AGENDA
PLANNING AND ZONING COMMISSION MEETING
CITY OF CREVE COEUR, MISSOURI
MONDAY, JUNE 15, 2020

**APPLICATION TO PLANNING AND ZONING COMMISSION
#20-002 & #20-010: BOUNDARY ADJUSTMENT, SITE DEVELOPMENT
PLAN AND CONDITIONAL USE PERMIT FOR QUIKTRIP GAS STATION
WITH CONVENIENCE STORE AT 11004, 11026, AND 11032 OLIVE
BOULEVARD AND 825 AND 827 GRAESER ROAD, AND THE
REDEVELOPMENT OF THE ADJACENT RETAIL CENTER
AT 11032 AND 11056 OLIVE BOULEVARD**

RE: Responses to Planning & Zoning Commission Comments & Questions
Proposed QuikTrip #613

Figure 2: Close-up of the Preliminary Demo Plan showing the location of the new entrance with the existing curb cuts, and the GIS image of the existing area.

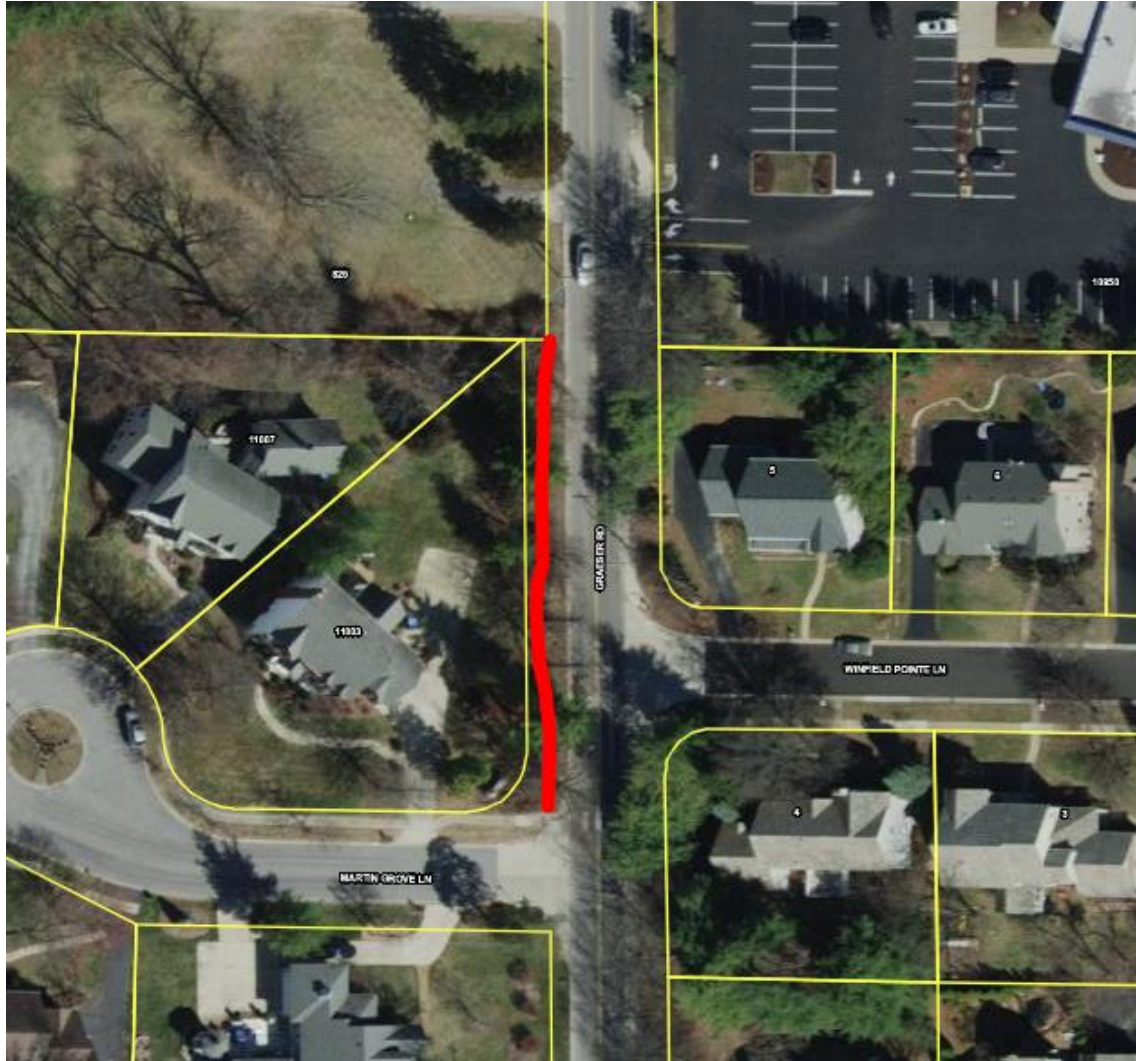
The site development plans submitted on May 11th, show that the proposed Graeser entrance curb cut is located between the two existing driveways for 825 and 827 Graeser Road, reducing the three curb cuts into one. CBB’s letter indicates that this location aids in the traffic impacts. Staff would note that it is considered a best practice to locate vehicular access points furthest from the intersection as possible and this appears to be the case with this proposal.

FUEL TANKER TRUCK MOVEMENT EXHIBIT

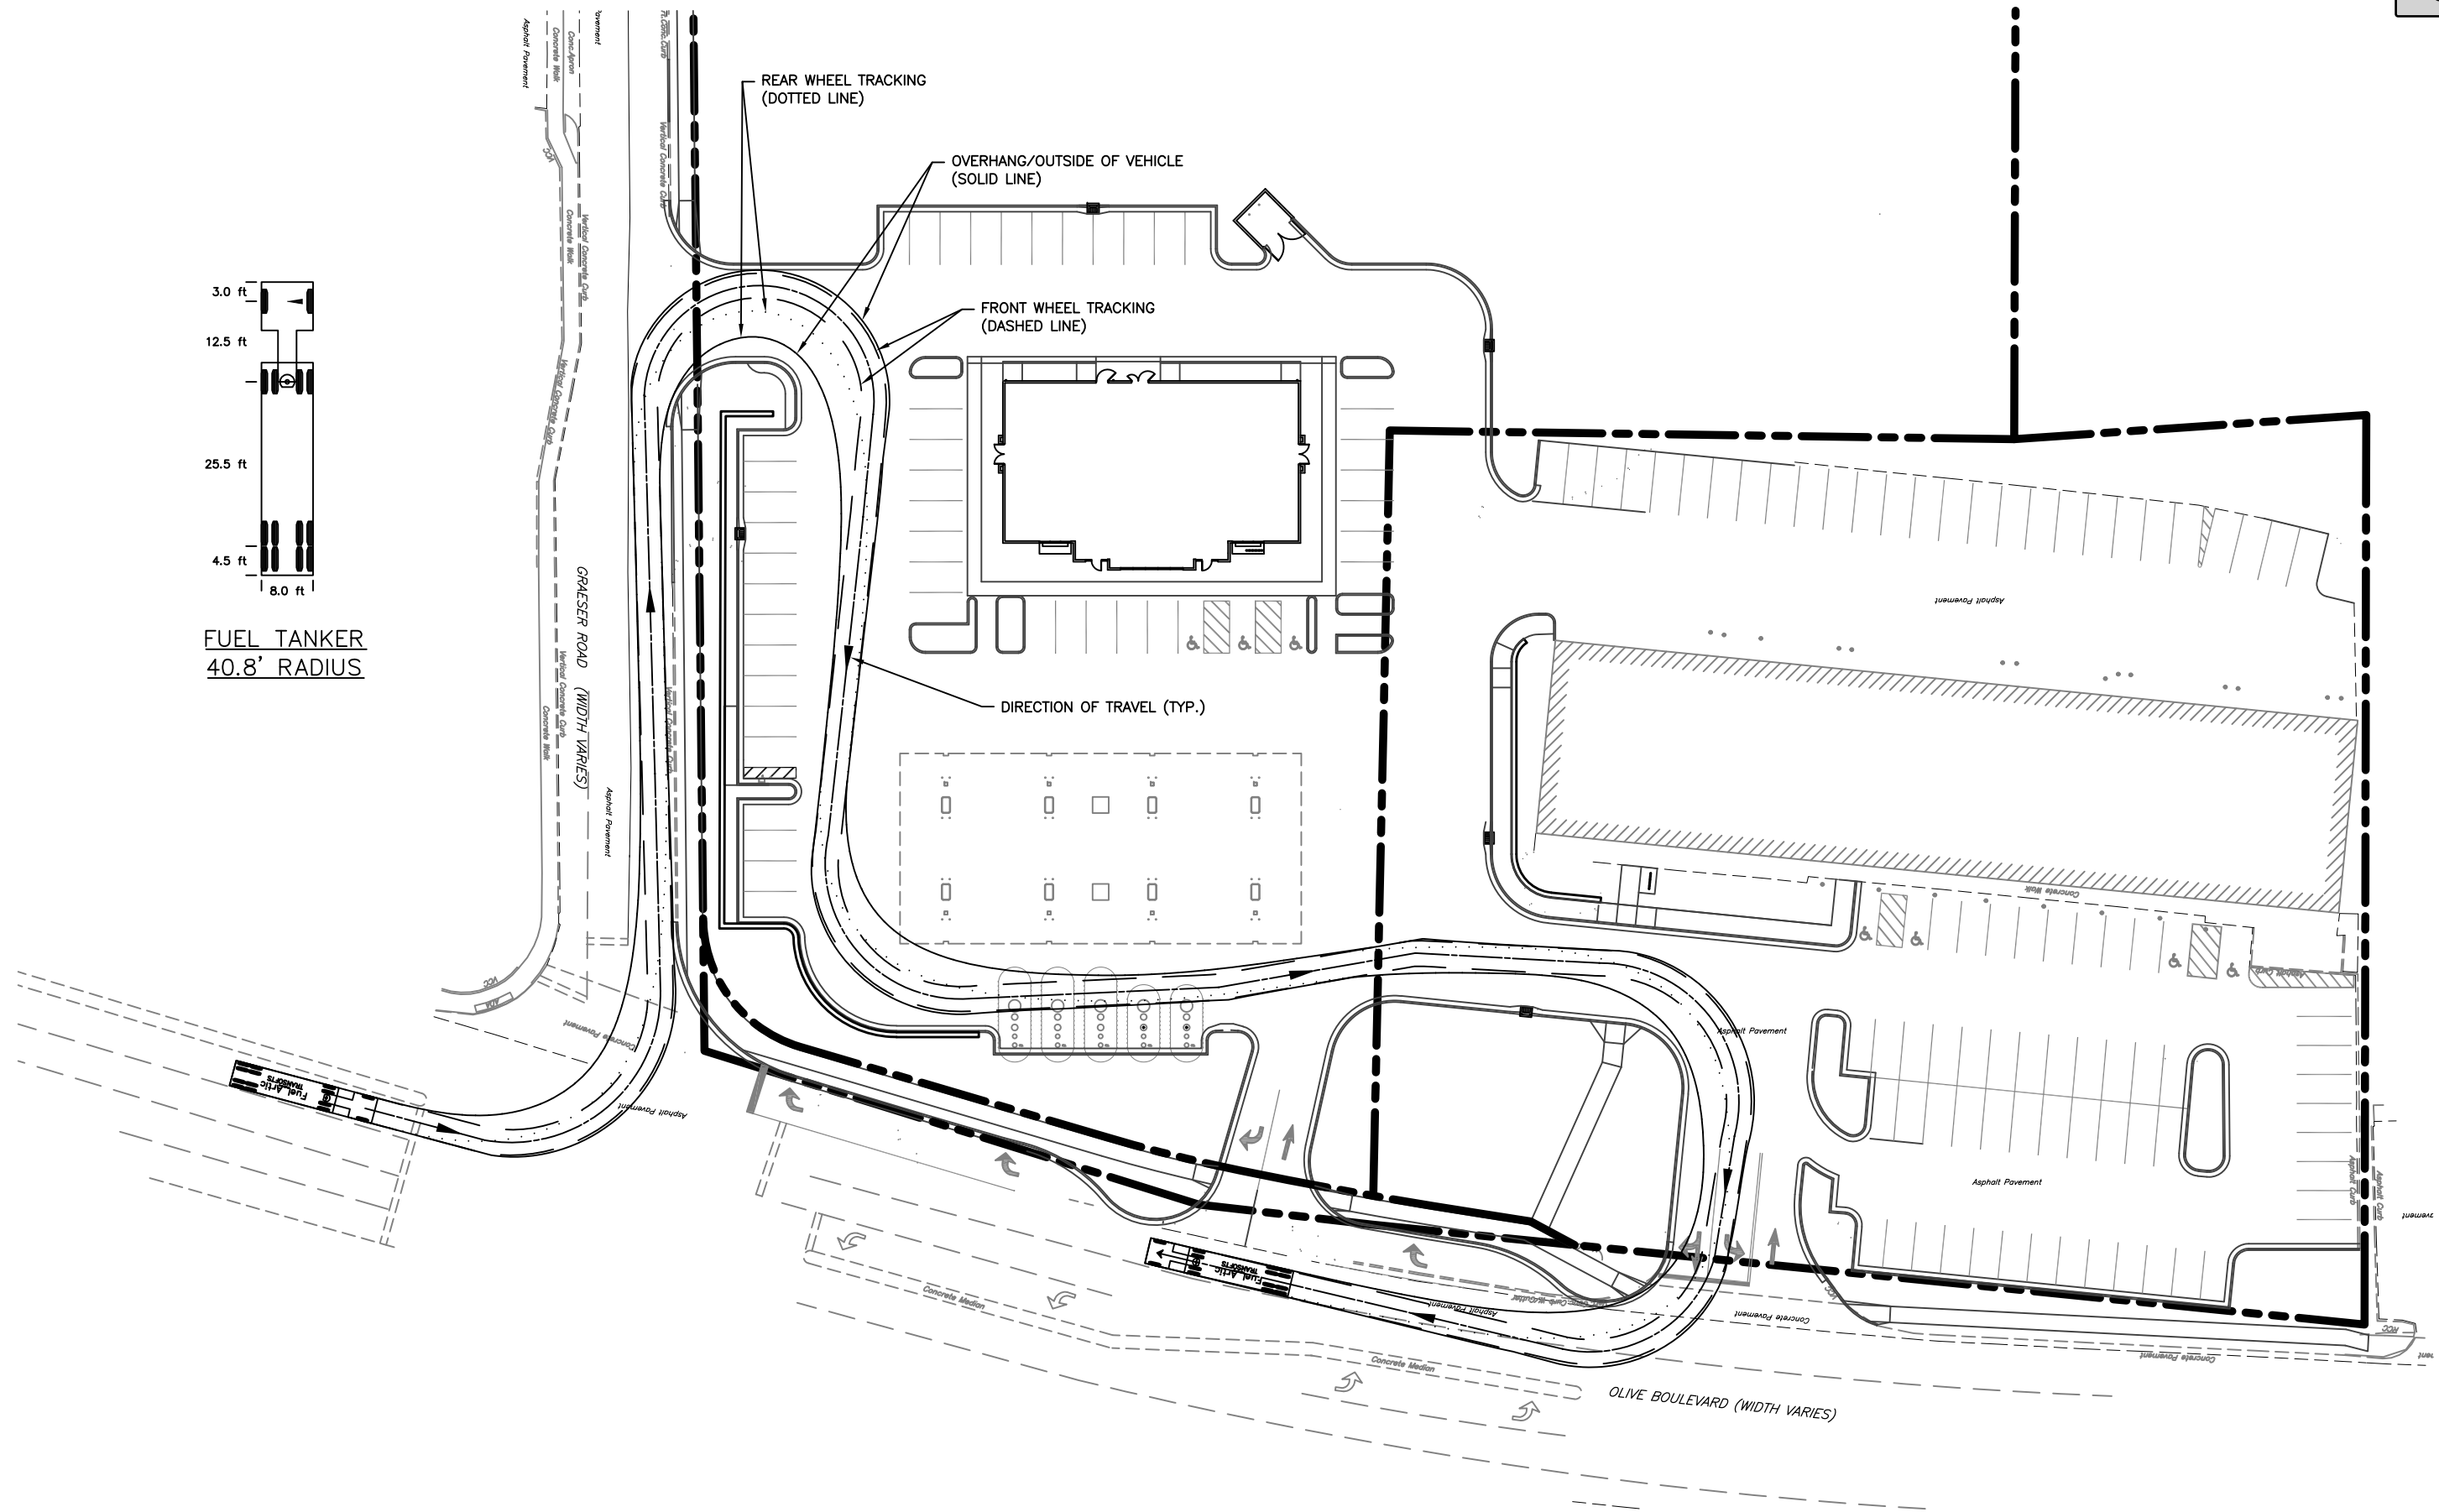
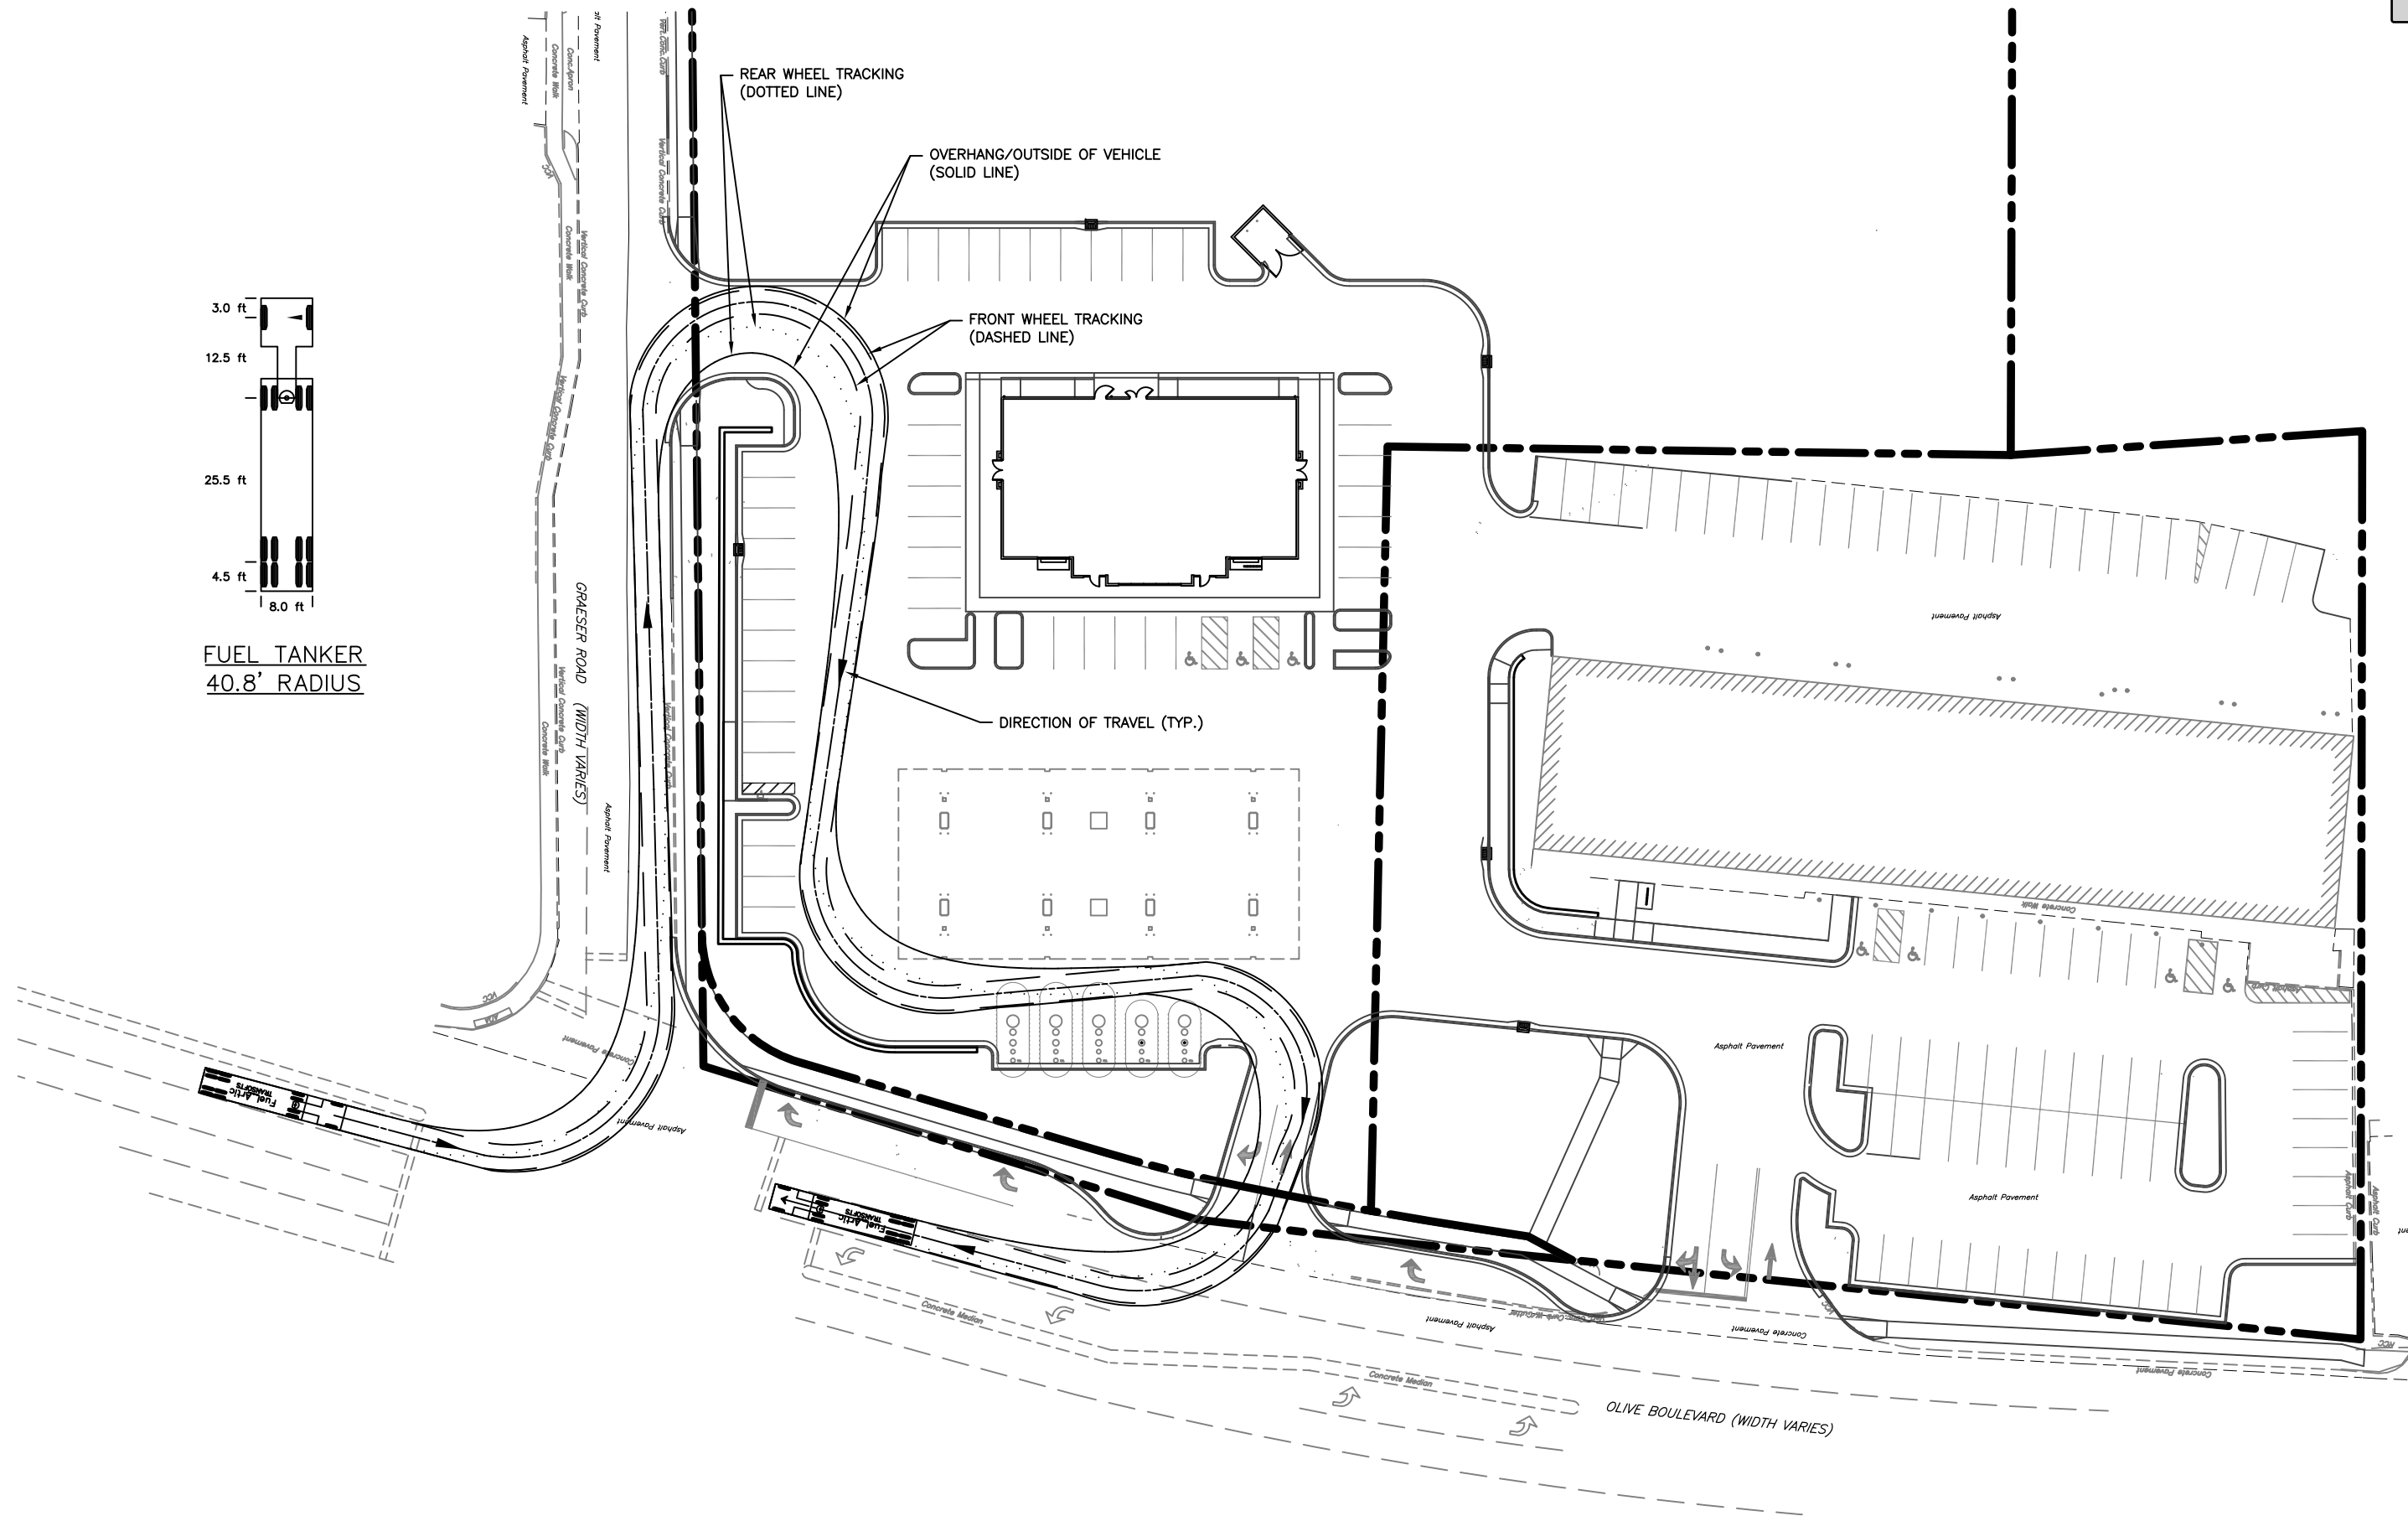
According to information provided by QT and CBB, they have adjusted the curb radius to better accommodate a turning truck. The Applicant has indicated a willingness to work with the City on scheduling the deliveries of the trucks to avoid rush hour/peak times. The Commission should discuss any further questions regarding deliveries with the Applicant.
